## Round OMA or AOP Specs to Closest 0.1dB

# Comment#2869: Table 75-5

Figure 75-3—10GBASE-PR and 10/1GBASE-PRX block diagram

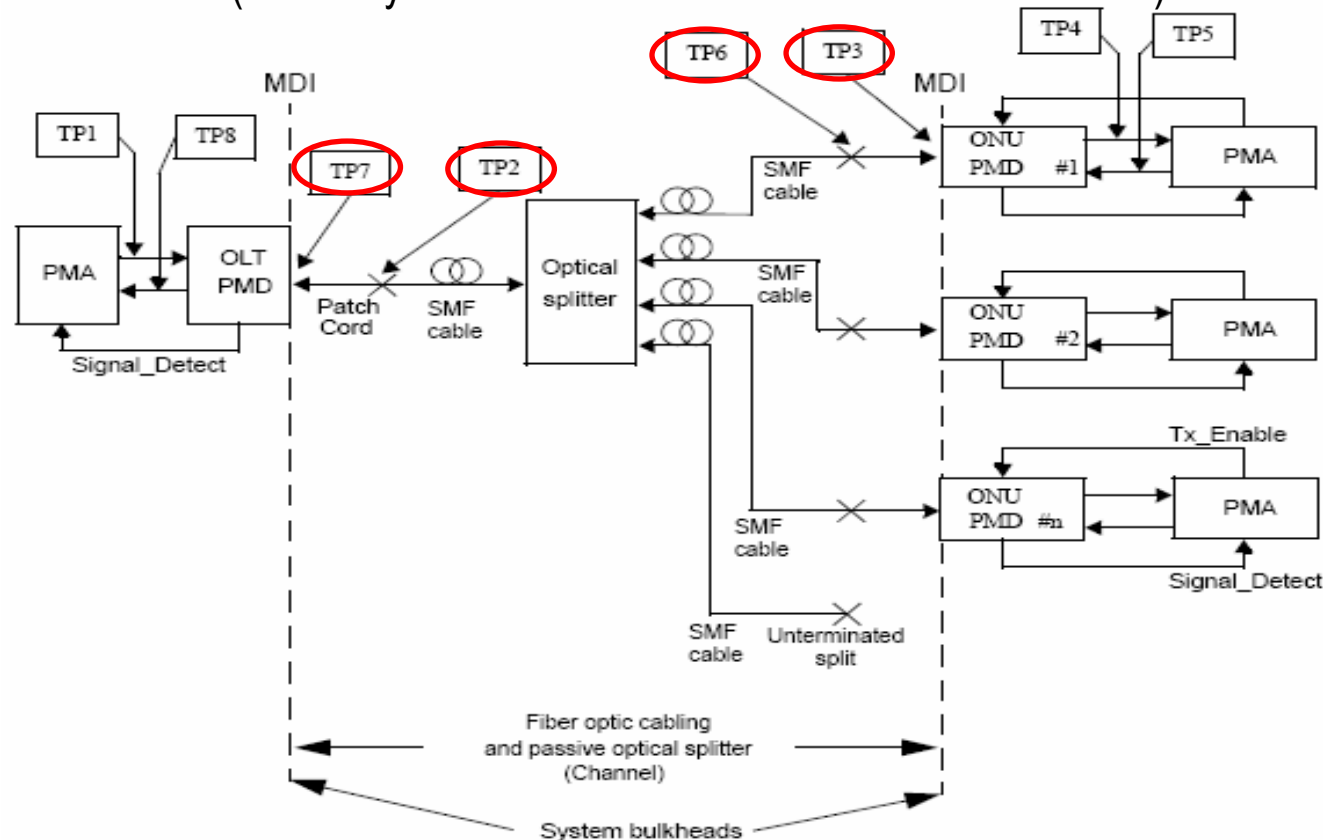
# AOP and OMA Spec'd Critical Compliance points

- ▶ In DS, TP2 and TP3 are critical compliance points for optical modules; while TP6 and TP7 for US.
- ▶ Typical the definition of AOP and OMA numbers should base on distribution of measured values from multi-vendors. (Too risky if all the numbers are based on calculation).
